CITY OF MILWAUKEE  
Department of Public Works  
Milwaukee Water Works  
Request for Proposal  
Inspection and Repair  
Linnwood To Riverside  
Effluent tunnel  
OFFICIAL NOTICE NO. 65-2014  
JULY 17, 2014

ADDENDUM NO. 3

CITY ENGINEER'S OFFICE, MILWAUKEE, WIS.  
MILWAUKEE WATER WORKS  
**RIVERSIDE PUMPING STATION  
VENTS**  
LINWOOD AVE. TUNNEL

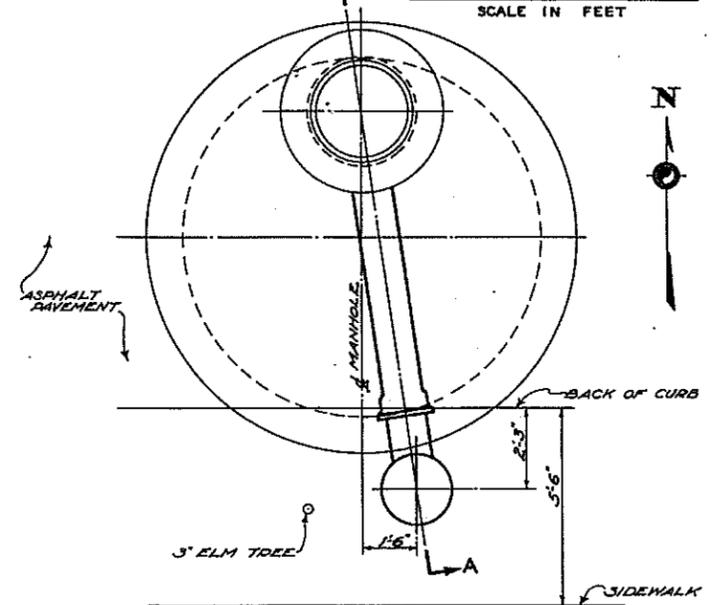
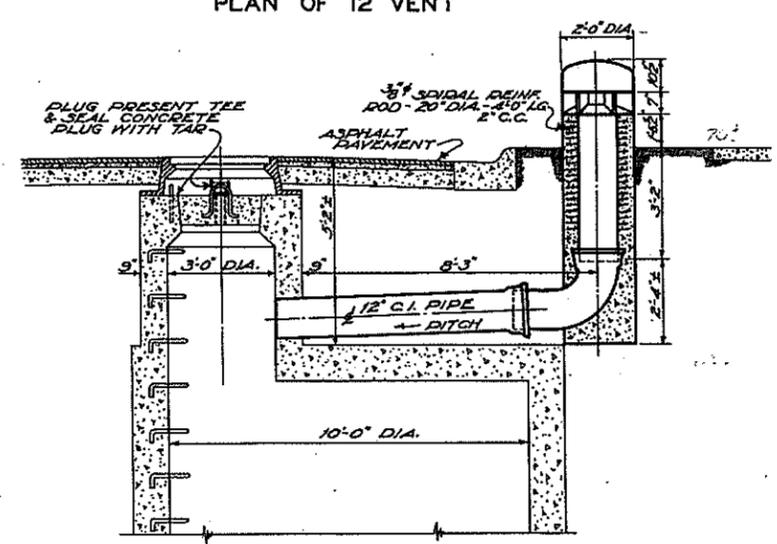
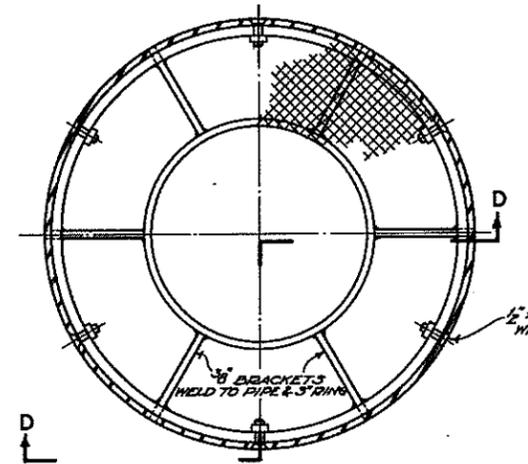
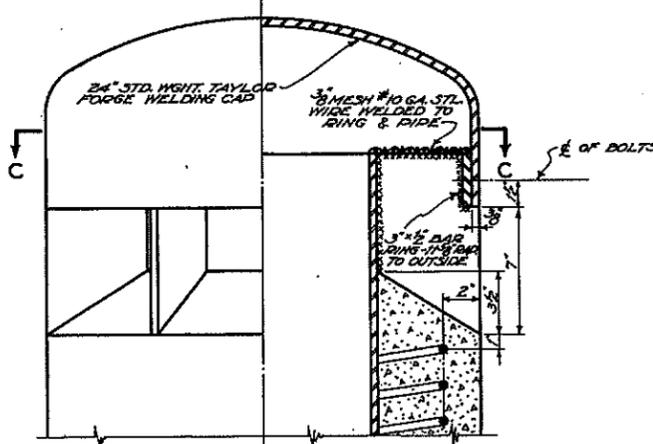
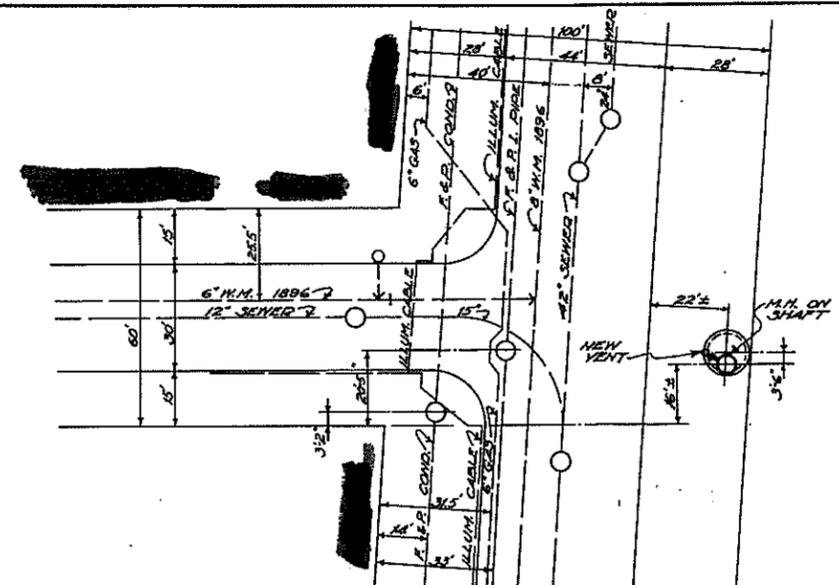
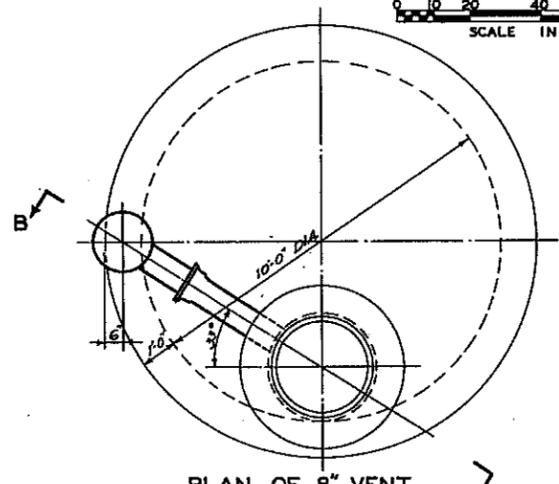
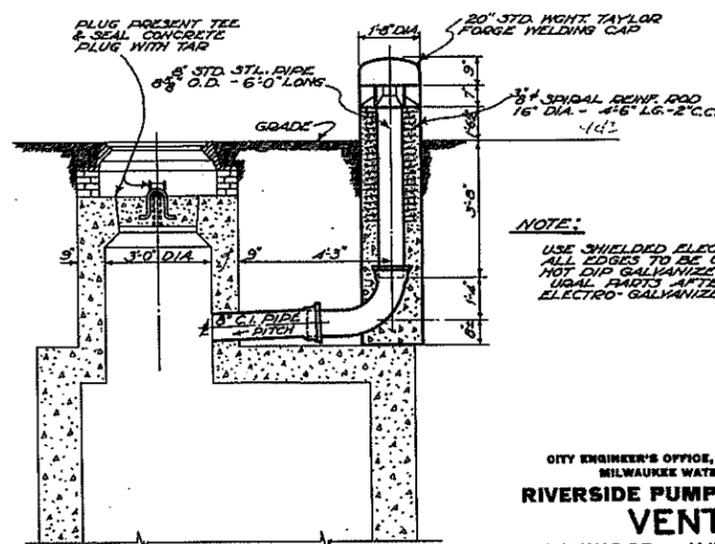
Does the site of each vent facilitate easy access? (No obstruction at exterior perimeter.)

Will the contractor have the ability to provide a secure perimeter around each location such as locked fencing to facilitate long-term access?

Can these vents be accessed and left open the duration of the project to be used as a potential rout for electrical, air hoses, water hoses.....or other necessary equipment?

Are these vents at grade/flush, or is access for these vents within a concrete chase elevated above grade like the entrance at the East end of the tunnel?

The spacing and location of the vents along the length of the tunnel system needs to be identified so the contractor can properly design the ventilation for the confined space entry. Can this information be provided?

**As stated above, the manhole/vent is actually covering a tapered plug. There is actually a covered vent that extends from the manhole to a location not far from the curb line. See drawing at end of the addendum.**

**As stated in the RFP, the contractor/consultant shall coordinate and obtain all necessary permits, security, and traffic modifications with the Milwaukee Water Works and the local governmental bodies in order to obtain such access. See drawing at end of addendum.**

**The Contractor/Consultant shall coordinate with the Milwaukee Water Works and the local government bodies the proper measures will be needed to maintain the openings. It is anticipated that these vents can remain open provided they are maintained and proper safety precautions are used. See drawing at end of addendum.**

**The manholes are flush with the grade, and the vent is about 24" above grade. See drawing at end of addendum.**

**The vents are approximately 4,200 feet apart. See drawing at end of addendum.**
